PUBLIC INTEREST REVIEW FOR GROUNDWATER APPLICATIONS

SUBJECT: Application G- 18299 Supersedes review of _____
Date of Review(s)

A. GENERAL INFORMATION: Applicant's Name: Kiprian & Anna Tipikin County: Clackamas

Figure 1: Water level data for a nearby well showing similar head elevations to that expected within proposed POA wells.

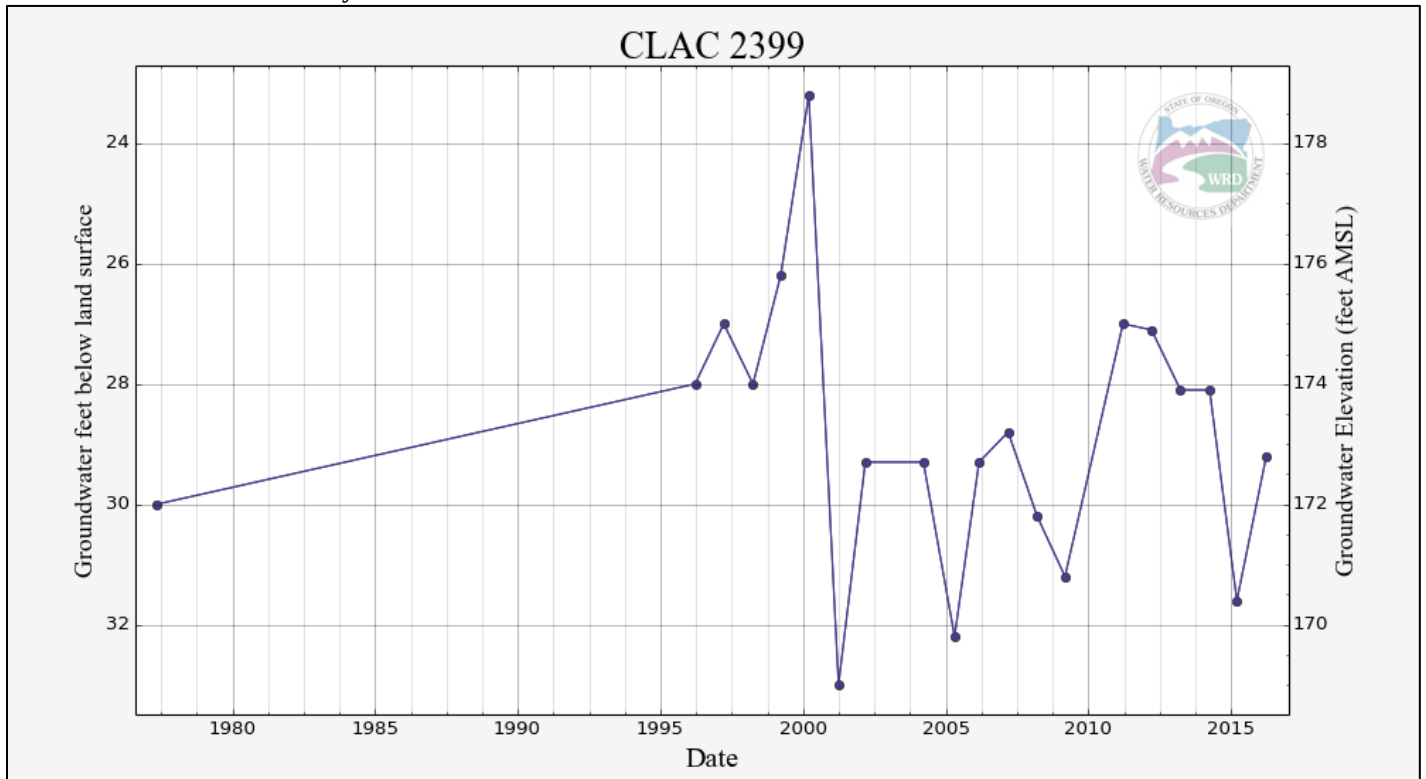
- B3. **Groundwater availability remarks:** Area wells with similar head elevations in the alluvial aquifer system show relatively stable water levels for the past two decades (see attached hydrograph). The closest nearby groundwater POA (CLAC 2460 on permit G-15132) is about 250 feet from the proposed location of "Well 2", but develops from a much shallower portion of the aquifer system. This is evidenced on the well log, in addition to a vast difference in head elevations between CLAC 2460 and the applicant's well on which construction of the proposed POA wells is based (~235' AMSL for CLAC 2460 versus ~175' AMSL for CLAC 64676).
